802.1ASbt presentation on Pdelay_Req storm issue

Bob Noseworthy (ren@iol.unh.edu)
University of New Hampshire's
InterOperability Laboratory (UNH-IOL)
IEEE 802.1 TSN TG
2014.05.14

The MDPdelayReq State Machine (per 802.1AS-cor)

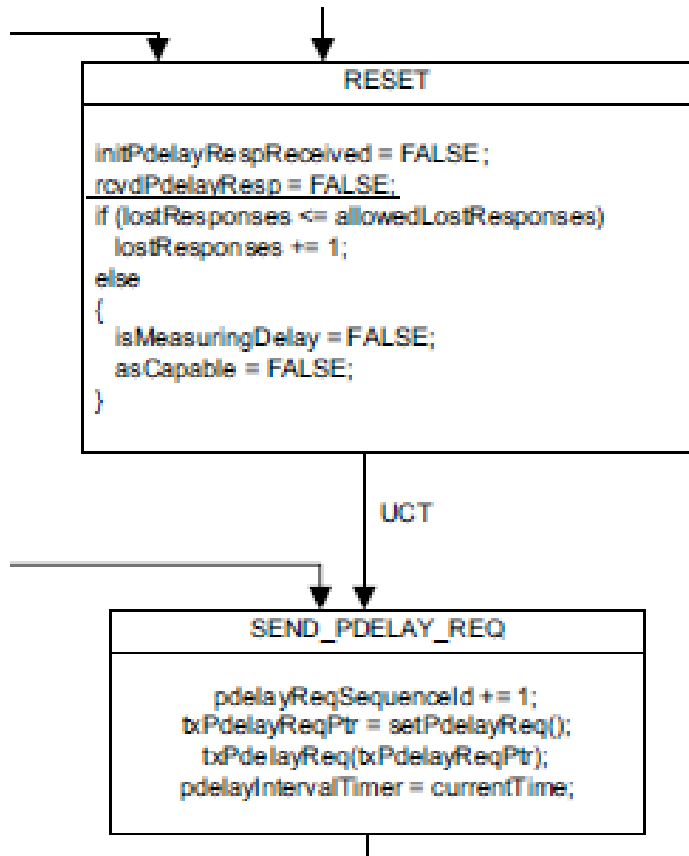
- Focus is on the transitions to the Reset state from:
 - WAITING_FOR_PDELAY_RESP
- And
 - WAITING_FOR_PDELAY_RESP_FOLLOW_UP

- Timeout occurs so go to reset (this is fine); or,
- rcvdPdelayResp && not thisClock, not thisPort, or rcvdPdelayRespPtr->sequenceId !=txPdelayReqPtr->sequenceId
- In this latter case, as soon as an errored Pdelay_Resp is received, a fresh Pdelay_Req frame will be sent, potentially **triggering a storm of invalid Pdelay_Resp and Pdelay_Req retransmissions**
- Transition to WAITING_FOR_PDELAY_RESP_FOLLOW_UP is conditioned on rcvdPdelayResp with proper thisClock, thisPort and seq. Id.

- Timeout occurs so go to reset (this is fine); or,
- (rcvdPdelayResp && (rcvdPdelayRespPtr->sequenceld == txPdelayReqPtr->sequenceld))
 - Causes transition to RESET if a 2nd Pdelay_Resp is received with same Seq.Id
- In this latter case, as soon as an errored Duplicate Pdelay_Resp is received, a fresh Pdelay_Req frame will be sent, potentially **triggering a storm of invalid Pdelay_Resp and Pdelay_Req retransmissions**
- Transition to WAITING_FOR_PDELAY_INTERVAL_TIMER is conditioned on rcvdPdelayRespFollowUp with proper sourcePortIdentity (thisClock, thisPort) and seq. Id (if not received, then the timeout condition will take us back to RESET)

- *Option 1:* Change the transition from RESET to SEND_PDELAY_REQ from “UCT” to “currentTime – pdelayIntervalTimer >= pdelayReqInterval”
 - In the event that a timeout occurred (causing the transition to RESET) then this condition will already be true (allowing for immediate transition to SEND_PDELAY_REQ)
 - In the case of an errored frame, this will cause a delay before the next Pdelay_Req is sent
- *Option 2:* Make all transitions INTO the RESET state conditioned only on “currentTime – pdelayIntervalTimer >= pdelayReqInterval”
- Option 1 is preferred (see next slide)

- Faulty responses trigger flood of frames on a link at the rate of the Pdelay responses
 - To introduce delay and force Pdelay_Req messages to be paced at their intended rate, change either:
 - the transition from RESET to SEND_PDELAY_REQ from “UCT” to “currentTime – pdelayIntervalTimer >= pdelayReqInterval”
- Or,
- remove all conditions on the transitions into Reset leaving only “currentTime – pdelayIntervalTimer >= pdelayReqInterval”
